Change No. 6  
License No. DPR-24

CHANGE NO. 6 TO THE TECHNICAL SPECIFICATIONS

POINT BEACH NUCLEAR PLANT UNIT NO. 1

DOCKET NO. 50-266

FIGURE 15.3.1-3

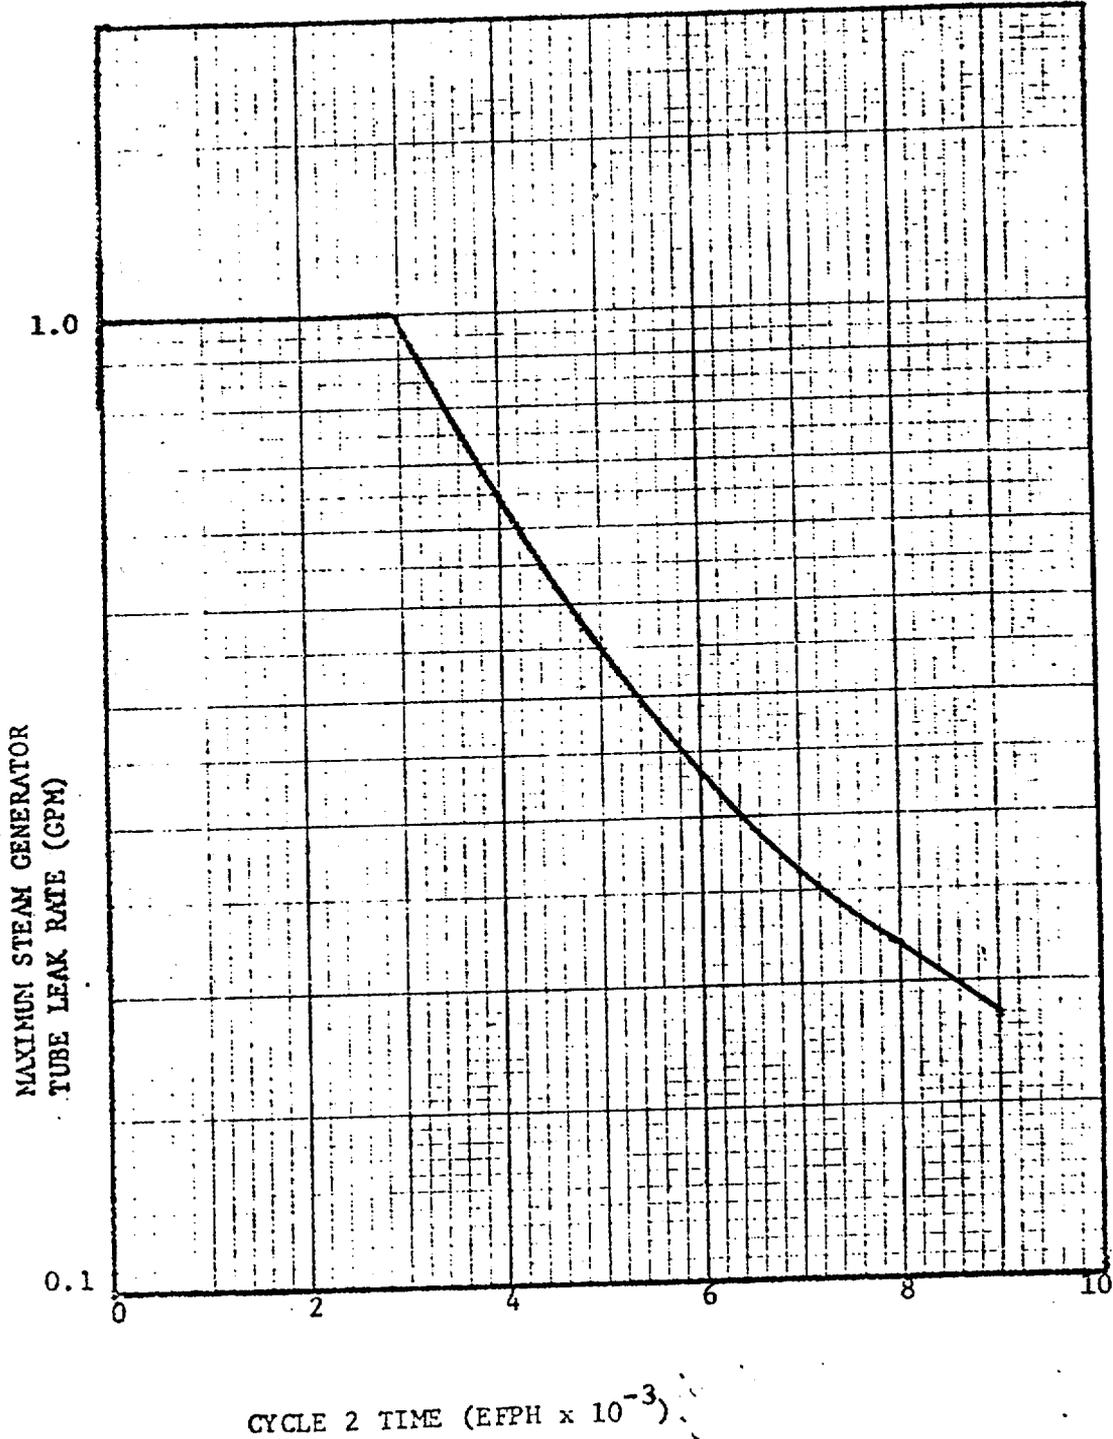
Also, the Figure 15.3.1-1 entitled "Maximum Steam Generator Leak Rate VS Time" should be removed from the Technical Specifications and the enclosed corrected Figure 15.3.1-3 inserted in the correct position within the Technical Specifications.

The curve in Figure 15.3.1-3 is a linear extrapolation between 8,000 EFPH and 9,000 EFPH. The end point (0.186 GPM) at 9,000 EFPH is obtained by multiplying the allowed leakage at 8,000 EFPH (0.22 GPM) by the ratio

of the predicted number of flattened fuel rods at 8,000 EPTH and 9,000 EFPH. This extrapolation is conservative since a best estimate extrapolation of the curve results in an allowed leakage of 0.194 GPM at 9,000 EFPH.

New leakage limits are based on straight line extrapolation of the limits as specified in Figure 15.3.1-3 of the Technical Specifications. Straight line extrapolation of the leakage limit vs. EFPH plot results in lower leakage limits than would a best fit extrapolation to the limit curve. The increase in EFPH, therefore, will result in no increase in the potential release of fission products in the event of a steam line break or a rod ejection accident as the small increase in potential fuel rod flattening is compensated for by a larger decrease in steam generator leakage rate limit.

Based on overpower transient 10 CFR 20 dose limits of 1.5 Rem thyroid
